**Bradley Farms Lot 34 Block 9, Preliminary Plan, 120100280**

One (1) lot requested for a religious institution; located at 9111 River Road (MD 190); RE-2 zone; 3.1-acres, 2002 Potomac Subregion Master Plan

**Staff Recommendation:** Approval with conditions and adoption of the Resolution

Figure 5 - Tree Variance

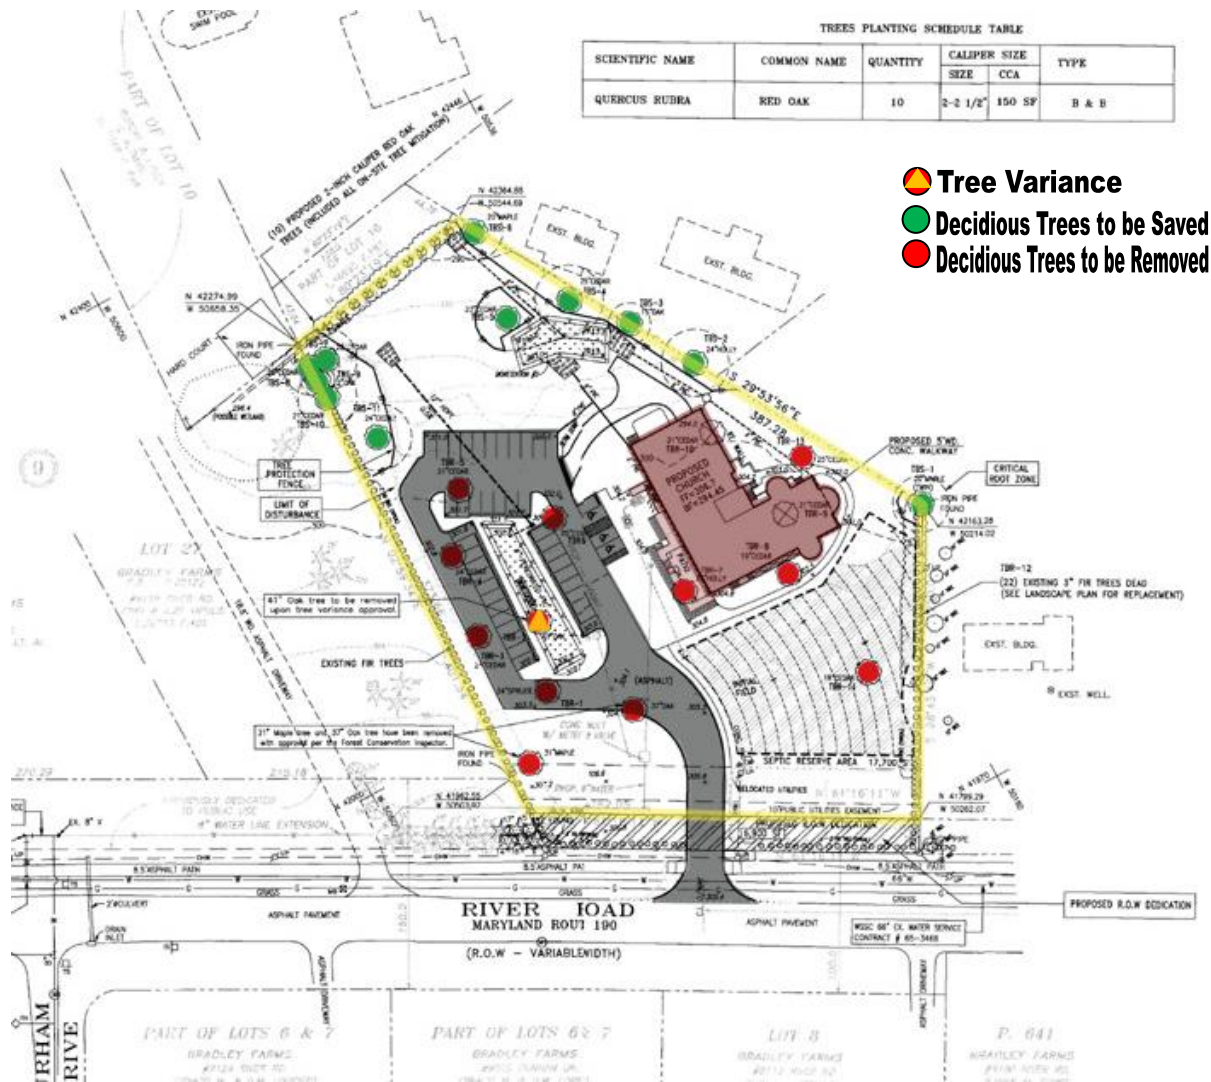
The Applicant submitted the request and proposed to remove tree # TBR-2, a 41 inch DBH oak; this requires a variance because the tree is 30 inches and greater DBH.

- b. Applicant must plant four – three inch DBH native canopy trees on the site as mitigation for the removal a 41 inch DBH oak.
3. The Planning Board has accepted the recommendations of the Montgomery County Department of Transportation (MCDOT) in its letter dated March 29, 2011, and does hereby incorporate them as conditions of the Preliminary Plan approval. The Applicant must comply with each of the recommendations as set forth in the letter, which may be amended by MCDOT provided that the amendments do not conflict with other conditions of the Preliminary Plan approval.

Mitigation should be at a rate that approximates the form and function of the trees removed. Staff recommends a replacement occur at a ratio of approximately one inch DBH for every four inches DBH removed, using trees that are two – to three-inches in DBH. This means that for the 41 caliper inches of the tree removed, it should be mitigated by the Applicant with four – three inch DBH native canopy trees on the Property. While these trees will not be as large as the trees lost, the trees will provide some immediate canopy to help augment the canopy coverage and over time fill in open areas where the large trees were removed.

**PRELIMINARY PLAN**  
LOT 34 BLOCK 9  
**BRADLEY FARMS**  
MONTGOMERY COUNTY, MARYLAND

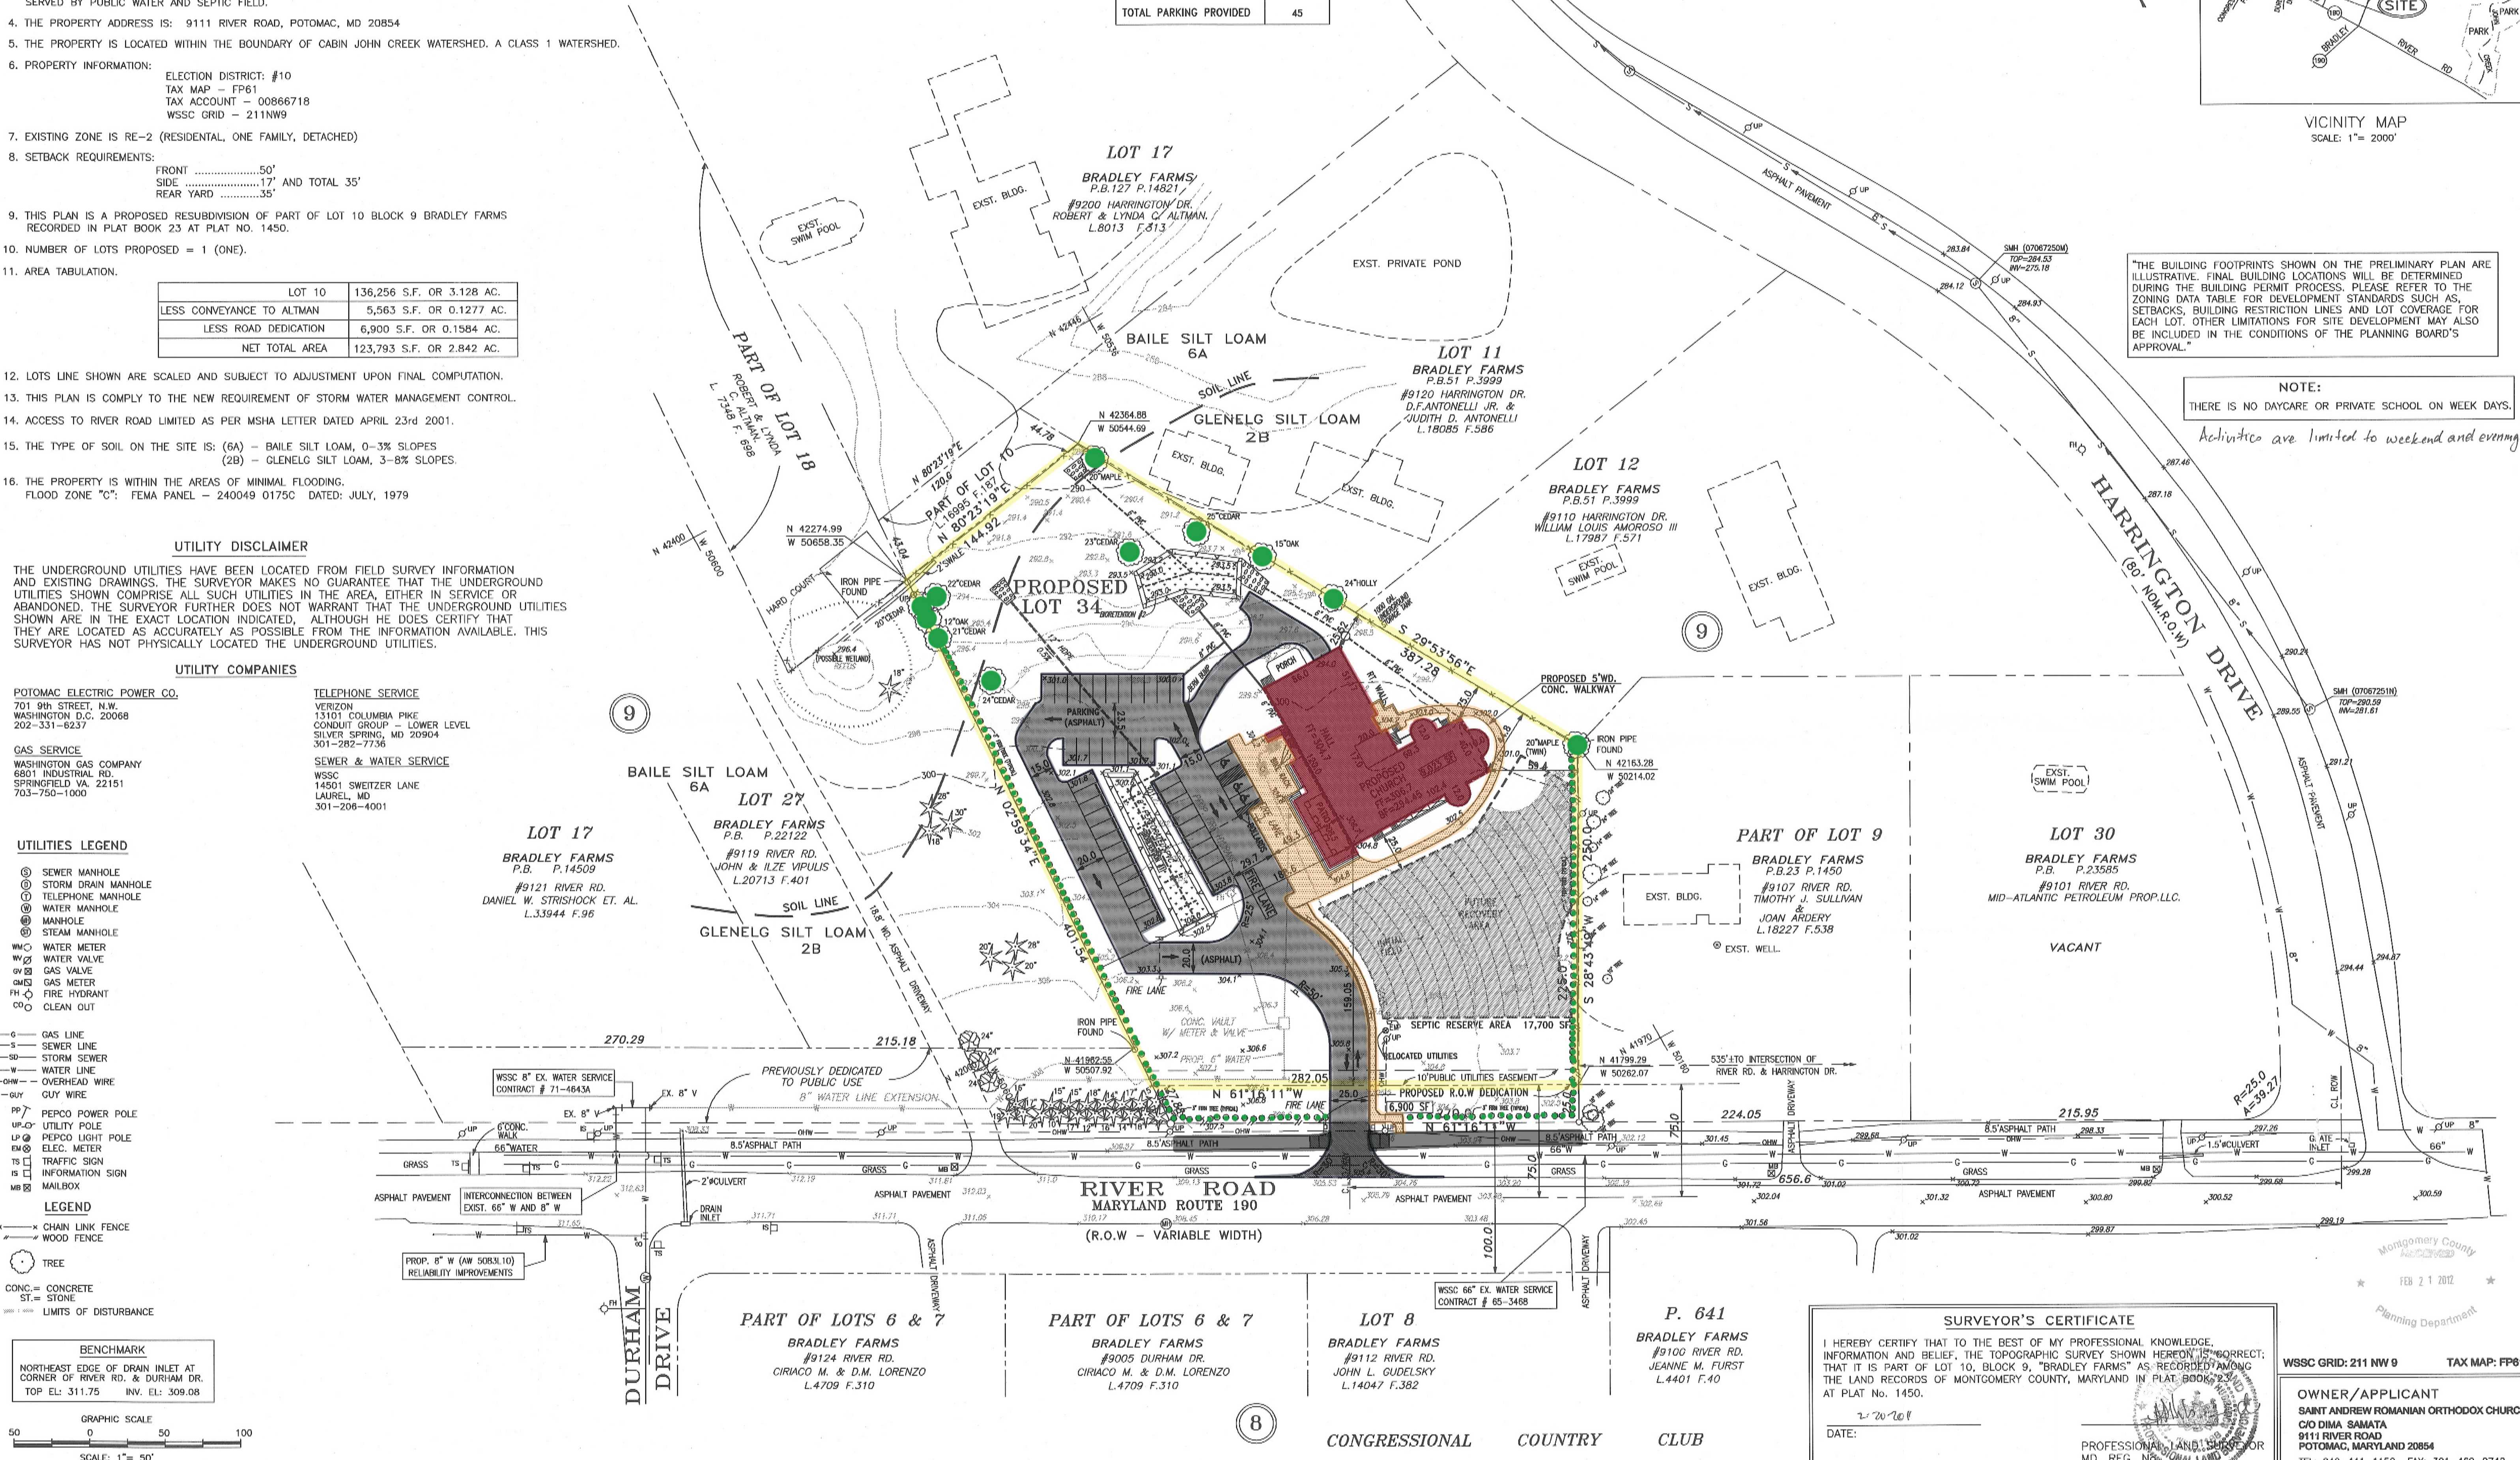
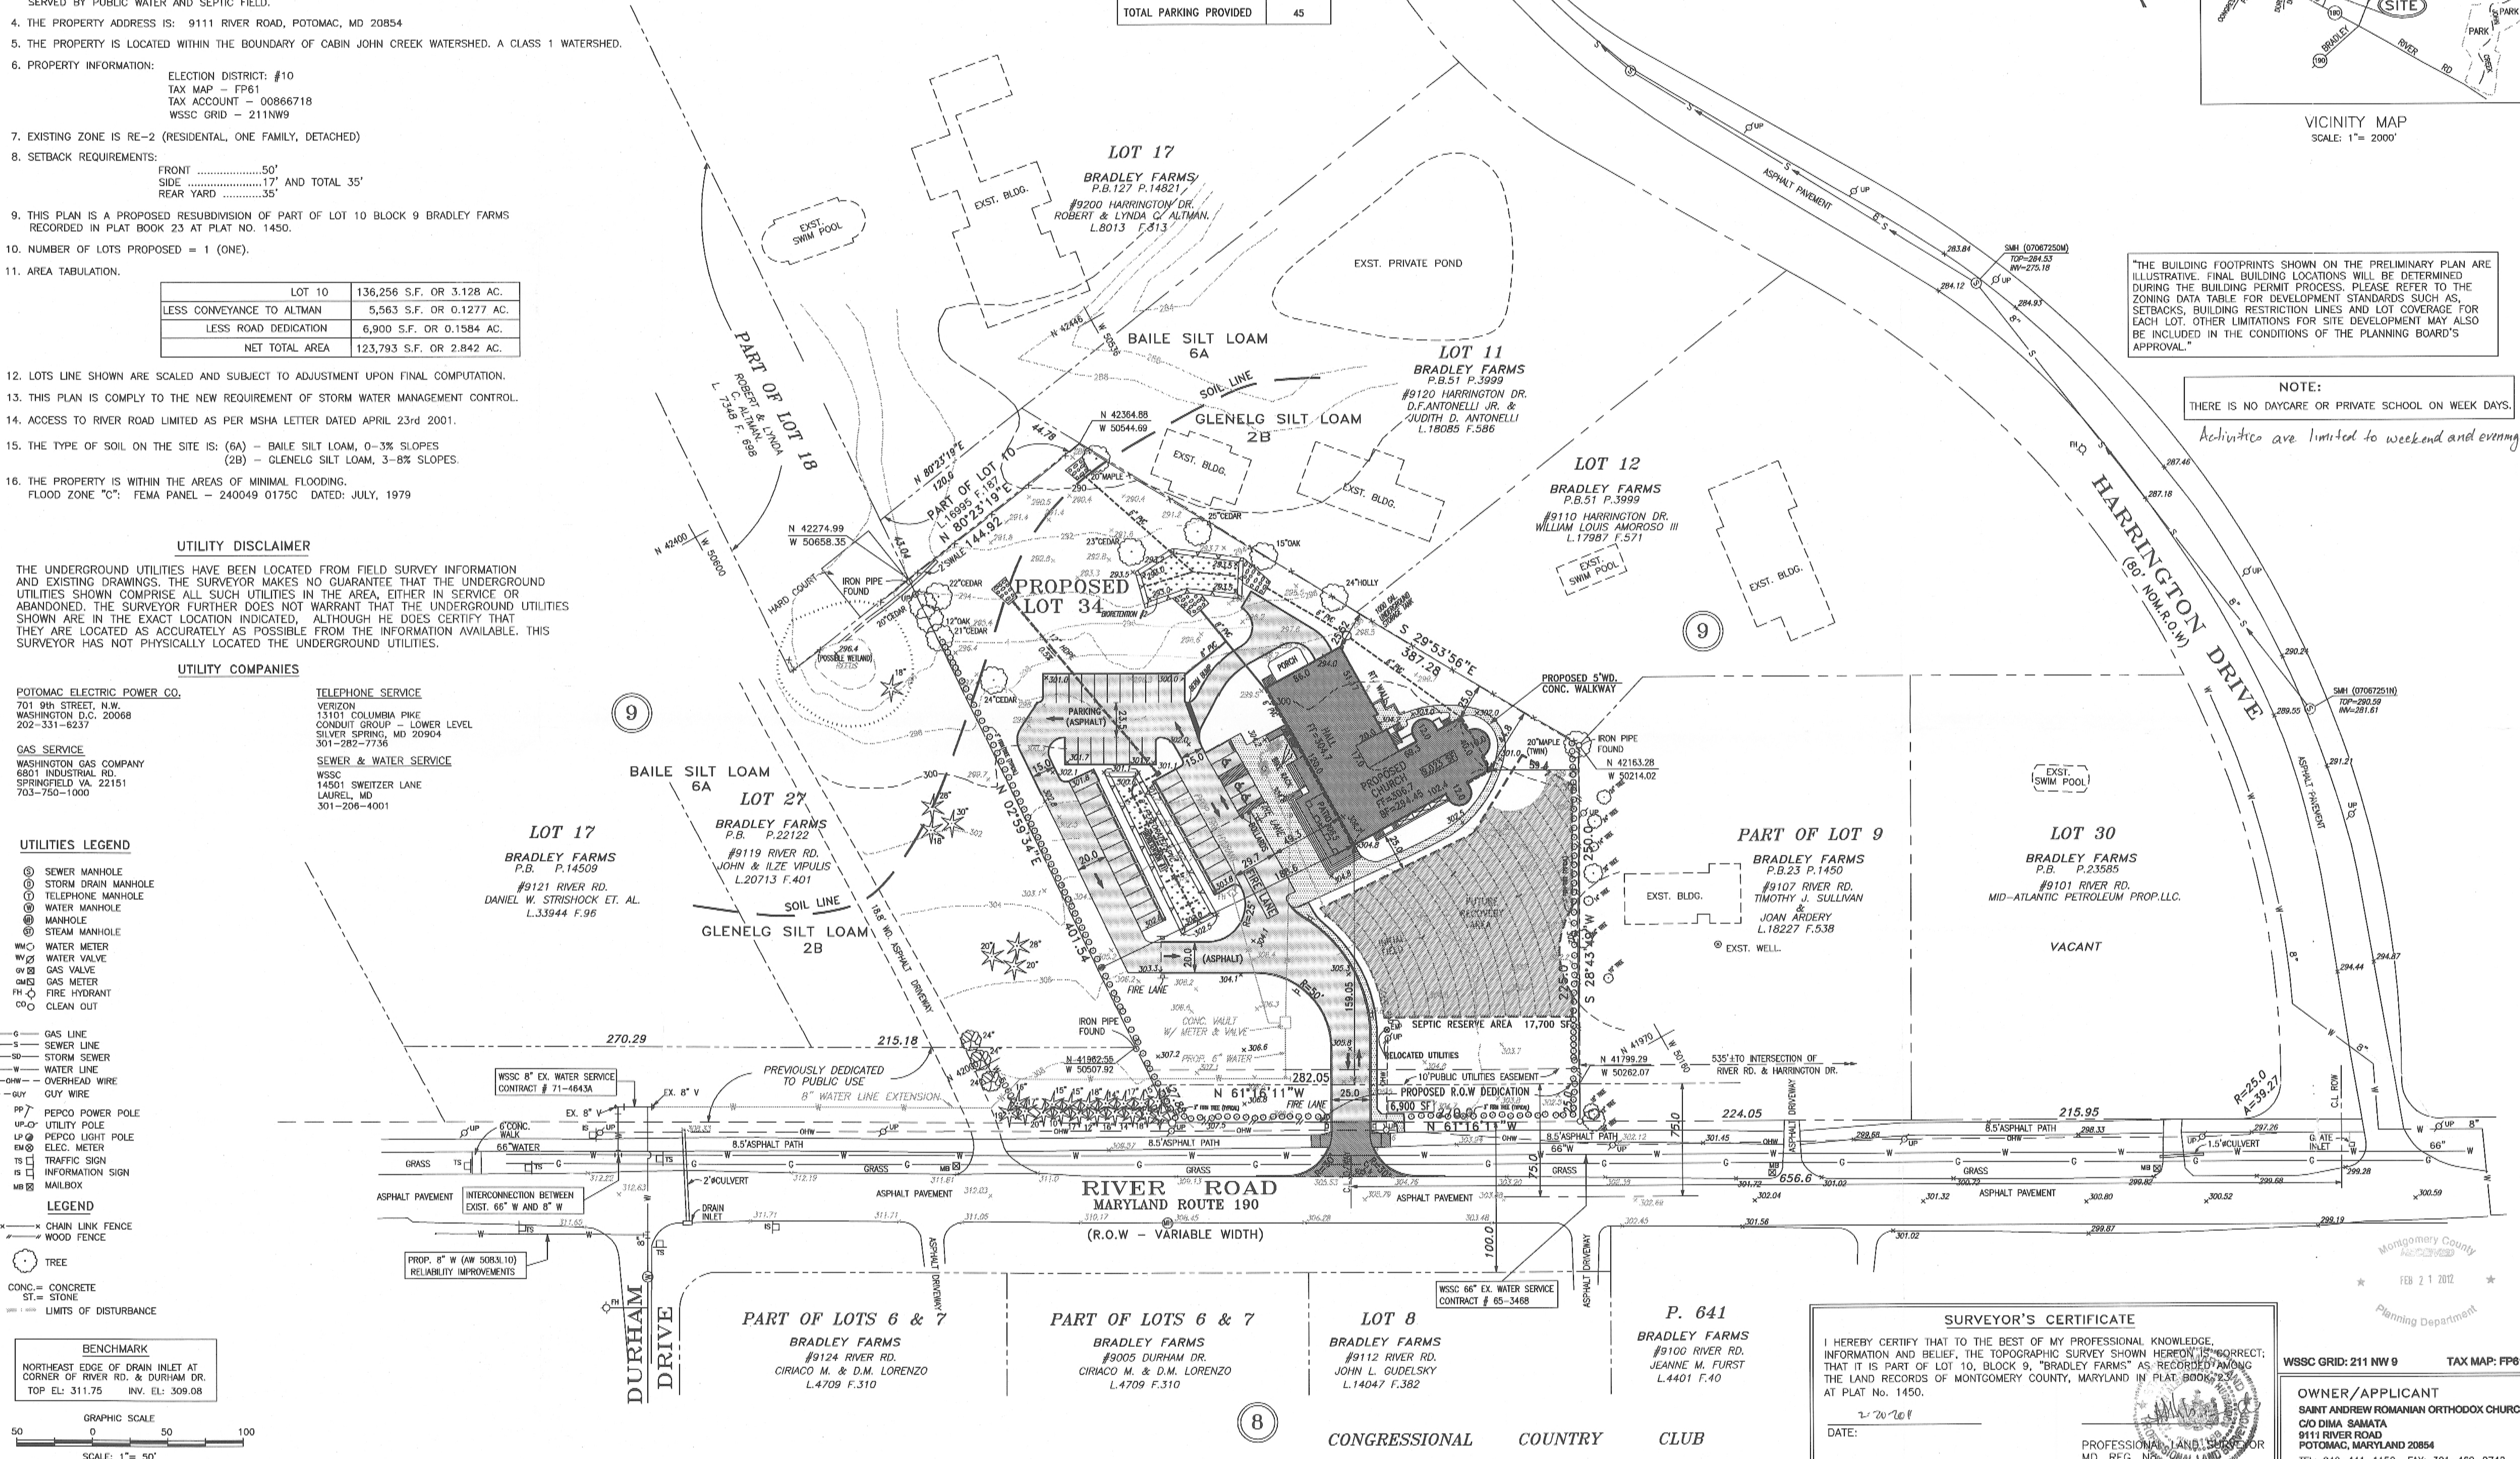
- The applicant must submit a sight distance evaluation on SHA worksheets that supports the proposed MD 190 entrance location.
- The proposed MD 190 entrance dimensions are insufficient. The applicant must revise the preliminary plans to increase the proposed MD 190 entrance to a 25' wide commercial entrance with 30' turning radii. The proposed entrance radii and 40' of the MD 190 tangency (20' from each radius) must be channelized with SHA type 'A' curb & gutter.

7. Provide on-site handicap access facilities, parking spaces, ramps, etc. in accordance with the Americans With Disabilities Act. Several of the proposed handicap parking spaces do not have access to paved surfaces; they should be modified as necessary to comply with the Americans with Disabilities Act.

8. Where perpendicular parking spaces border a sidewalk, a two (2) foot vehicle overhang is assumed. The applicant should either provide a seven (7) foot wide sidewalk or wheelstops within those parking spaces.
